Staff Report

Date: April 24, 2019

Re: An Amendment of the PLNSUB2015-00218 – 326 W Reed Avenue Marmalade Courtyards

Planned Development

Figure 1: Site Plan

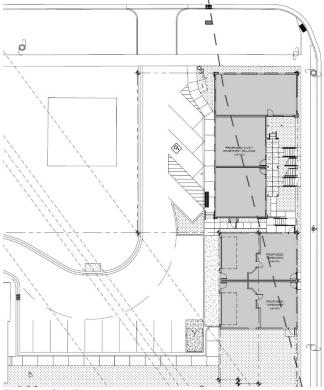
An active fautline runs north/south through the subject property. A portion of this faultline extends from the north/west portion of the existing northernmost building towards the south to the south/east portion of the existing southernmost building. Attempting to rehabilitate the two existing structures becomes problematic due to the faultline running the length of the existing building footprints. While the proposed replacement structures will also be located on the same footprint additional structural consideration can be made to ensure the safety and livability of the proposed units for future residents.

The proposed amendment will **not** affect the previously approved footprints of the two residential buildings, nor will it affect the number of units or the number and location of proposed parking stalls.

The proposed amendment **will** require modification to the zoning requirements, this is a request to modify the required 10' front yard setback, 10' corner side yard setback, and the street facing façade entry required on 800 North. The proposed amendment will maintain the current setbacks on the site as the applicant is proposing to demolish the existing buildings, the structures are no longer considered legal noncomplying.
